PR24 redeterminations

# **Response to South East Water's statement of case**

**Figure 4.1 Per property resilience costs including contingent allowance**

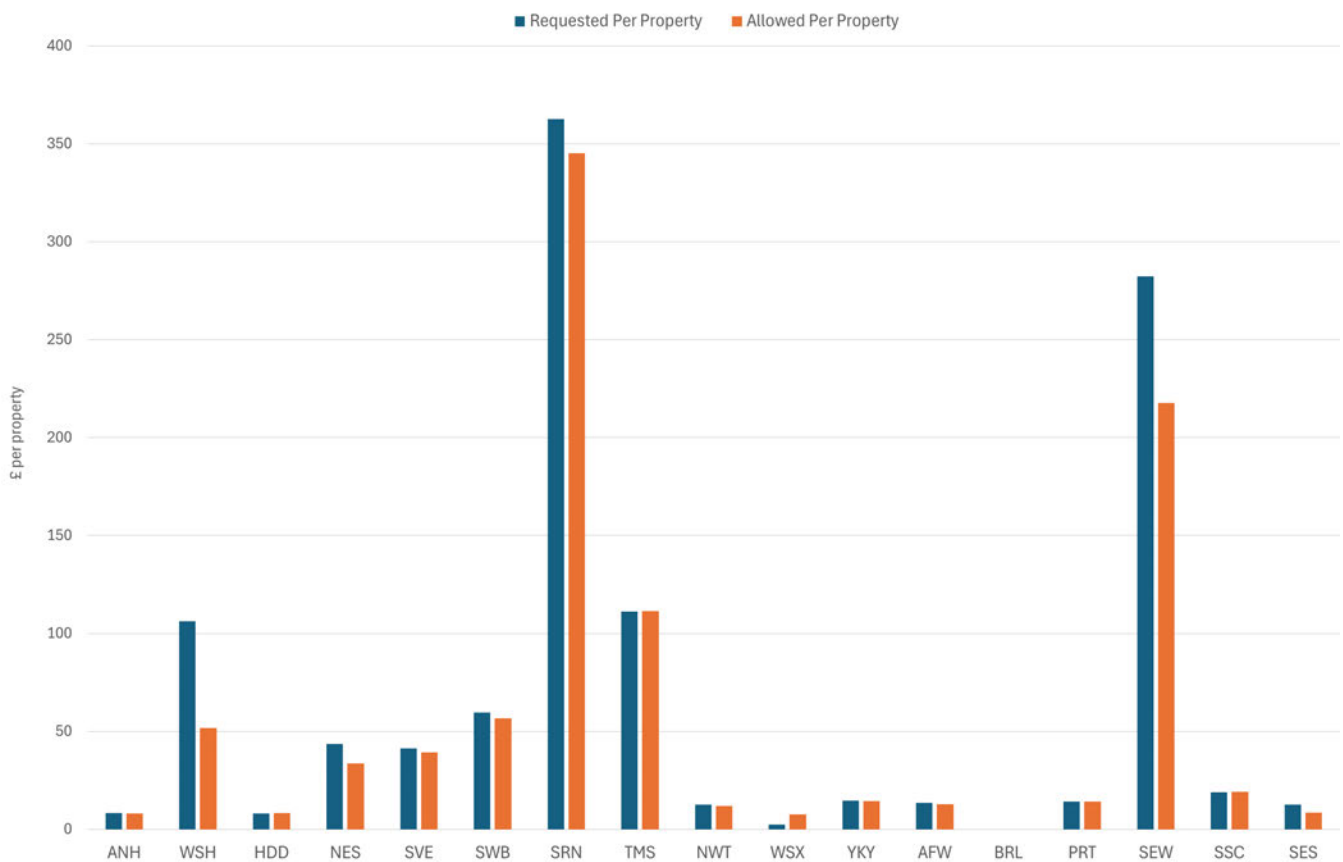
4.38 We also highlight in Figure 4.1 that on a per property basis, both the request and the allowance is the second highest in the sector and more than double that of the third place company.

**Figure 4.3: Cost per action of company's DrPWA final determination expenditure requests<sup>160</sup>**

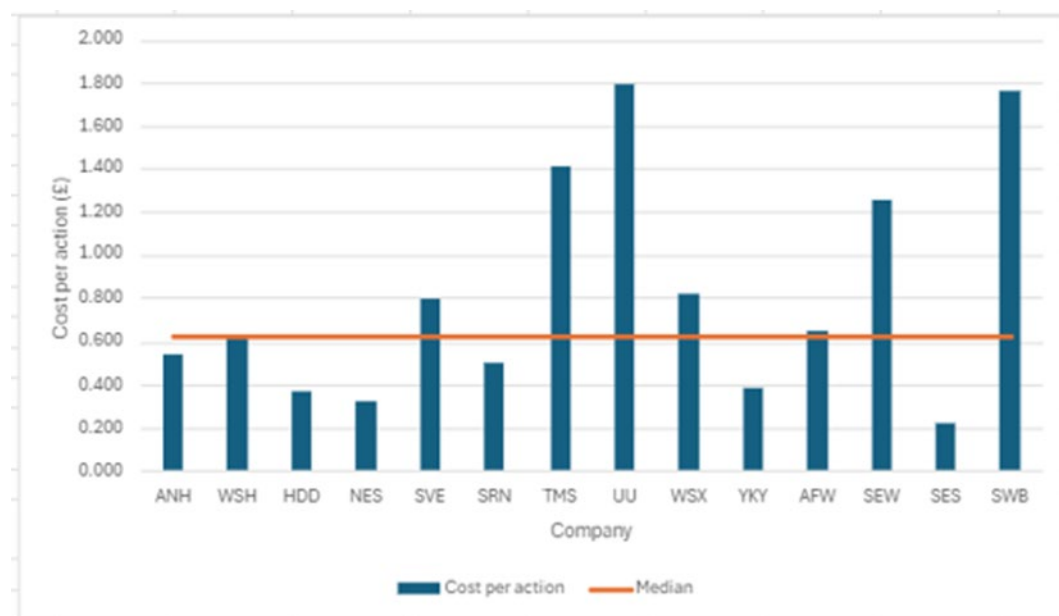
4.203 Although the company provided additional evidence, we still had concerns on cost efficiency. Following a query [OFW-REP-SEW-038<sup>157</sup>] South East Water presented a snapshot of the cost sheet it uses across its WINEP programme and an example for an investigation scheme.

4.204 South East Water did not provide detailed cost sheets for the DrWPA Implementation and No Deterioration schemes which the company was requesting expenditure for under the DrWPA business plan line. The company did not provide new evidence in the form of activity cost breakdown or evidence of benchmarking for these schemes which was raised in the draft determination deep dive assessment.<sup>158</sup> This would have been useful evidence given the company's request was high compared to other companies (refer to Figure 4.3 below). Therefore, for the final determination we retained our draft determination approach and applied a 10% adjustment for 'cost efficiency'.<sup>159</sup>

**Figure 4.4: South East Water supply interruption performance since 2015-16 compared to the sector median<sup>174</sup>**

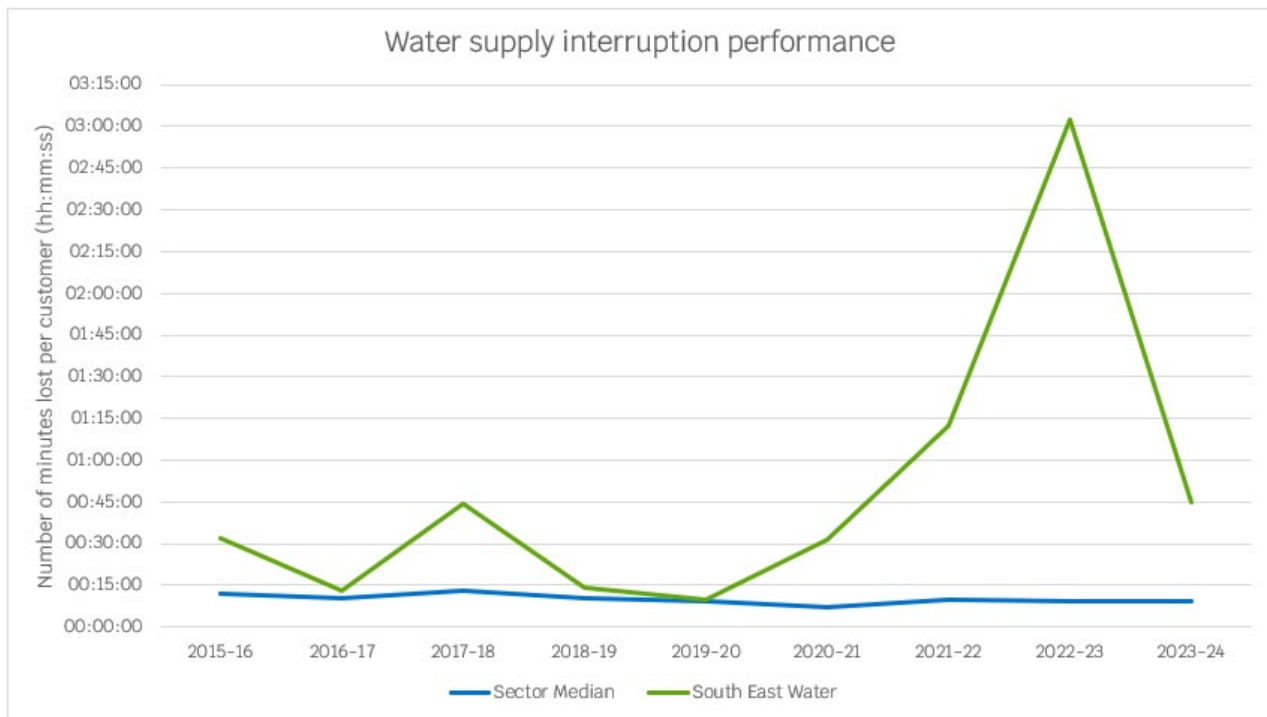
- 4.224 We recognise that the PR24 PCL is a challenging target for poorer performing companies, such as South East Water. South East Water's performance for water supply interruptions has been worse than the median performer in each of the least nine years and generally by a large amount, as shown in the figure below.

4.225 While the sector median has gradually improved over the period, from 12 minutes in 2015-16 to 9 minutes 18 seconds in 2023-24, South East Water has failed to improve over the period. Its performance has been particularly poor during the past three years. It ranks last out of all 17 companies for average water supply interruption performance over the period 2021-22 to 2023-24. This is despite stating, in its PR19 business plan, that the company will aim to reach 5 minutes 30 seconds in 2020-21 and down to 4 minutes by 2024-25.<sup>175</sup>

**Figure 4.5 – South East Water Southern Water and Hafren Dyfrdwy: Water supply interruption performance since 2015-16 compared to the sector median<sup>207</sup>**

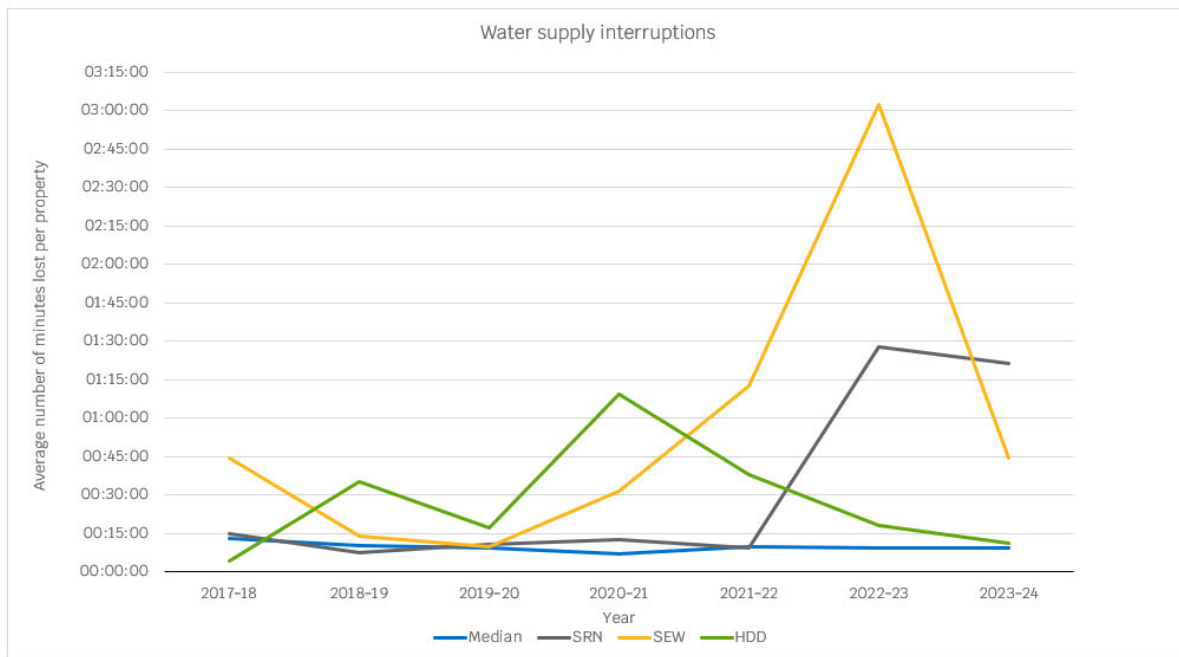
4.252 Water supply interruptions is a key area that South East Water needs to improve on. Figure 4.5 shows that South East Water has consistently underperformed against the industry median and other poor performers. During the first four years of PR19, the three poorest performers are Hafren Dyfrdwy, Southern Water and South East Water (with South East Water ranking last).<sup>204</sup> Southern Water performed in line with the industry median until 2022 and Hafren Dyfrdwy's performance has now returned to industry median after a peak in 2020–21, where the spike in performance was largely a result of a single point of failure in relation to the Wrexham trunk main, which the company is being funded to improve at PR24.<sup>205,206</sup>

**Figure 4.6 South East Water, Southern Water and Hafren Dyfrdwy: Water Supply Interruption ODI payments 2020–24 in (%RoRE) <sup>209</sup>**

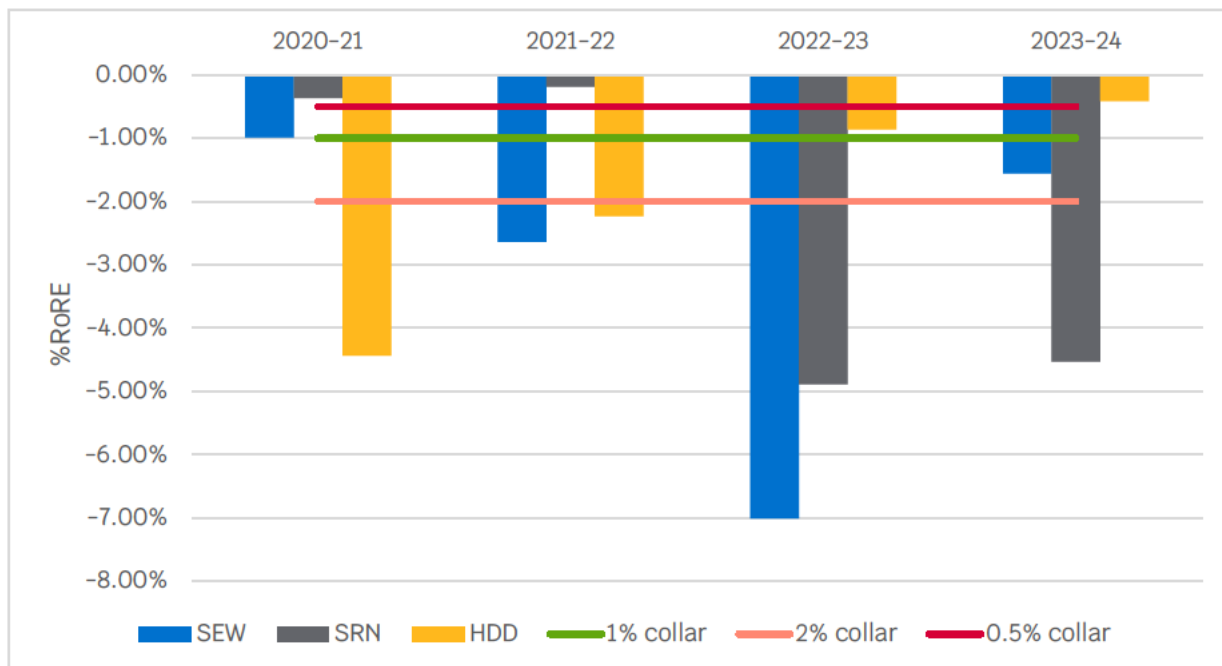
4.253 Figure 4.6 highlights, based on historical performance for these companies the impact of setting a collar at different levels. The figure shows the -2.0% collar set at PR24 for South East Water, the -1.0 RoRE collar we have set for all other companies and South East Water's proposed -0.5% RoRE collar.<sup>208</sup> We consider that once a collar is hit, the financial incentive to minimise the number and duration of supply interruptions is diminished, as the company cannot receive any additional ODI penalties for further deterioration in performance.

4.254 While the company has proposed a collar of -0.5% RoRE, we consider that even the -1% RoRE collar set for all other companies would not maintain incentives for South East Water. Figure 4.6 shows that South East Water is the only company that would breach a collar of -1% RoRE in all years.
